Comment Summary

Application #: PL202400150

Address: 1601 and 1701 American Blvd W, 8033 Knox Avenue S, and 1600 W 81st Street

Request: **Preliminary and final development plans for an approximately 54,000 square foot, two-story auto dealership facility**

Figure 26 Accessible boarding area (ADA pad)

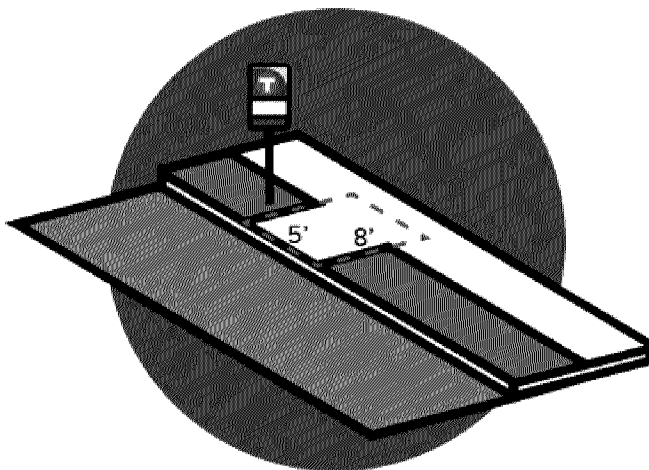
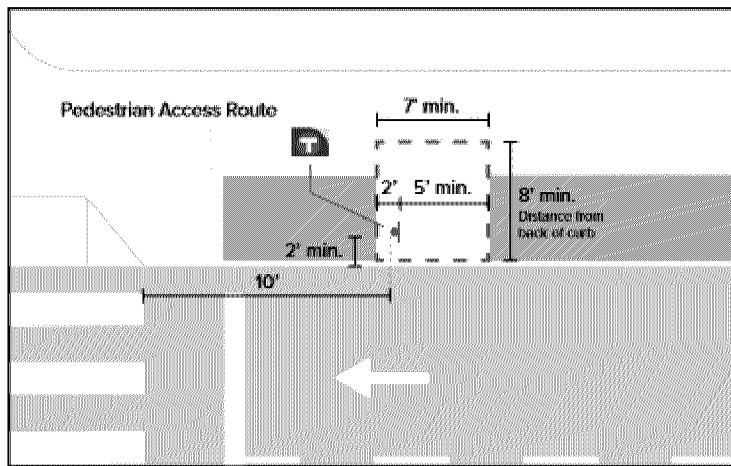
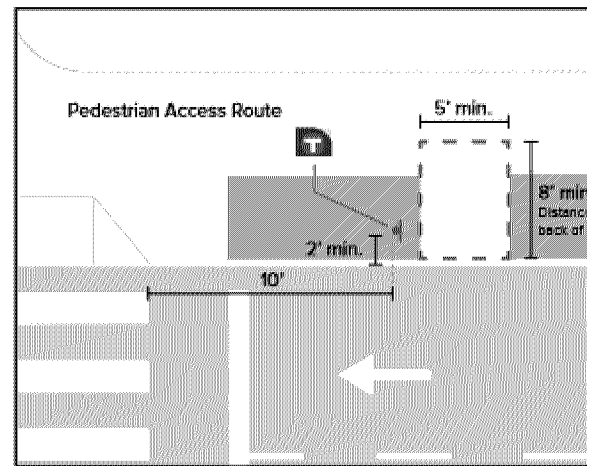
As for Metro Transit comments, we only have one stop that might be impacted by the development project. This is a westbound Route 4 stop on West 81st Street at Knox Avenue. If the project is going to reconstruct sidewalks along the southern side of the parcel, this would be a good opportunity to add an ADA pad for the stop.

As per our Regular Route Bus Stop Design guide ([Figure 26](#)), this would be a 5' wide and 8' deep firm and stable surface that connects the sidewalk to curb.

Please ask that the design team update the plans to show an ADA accessible connection between the sidewalk and curb at stop #57159. The designer should assume that stop #57159 will be kept at the same location as it is today.
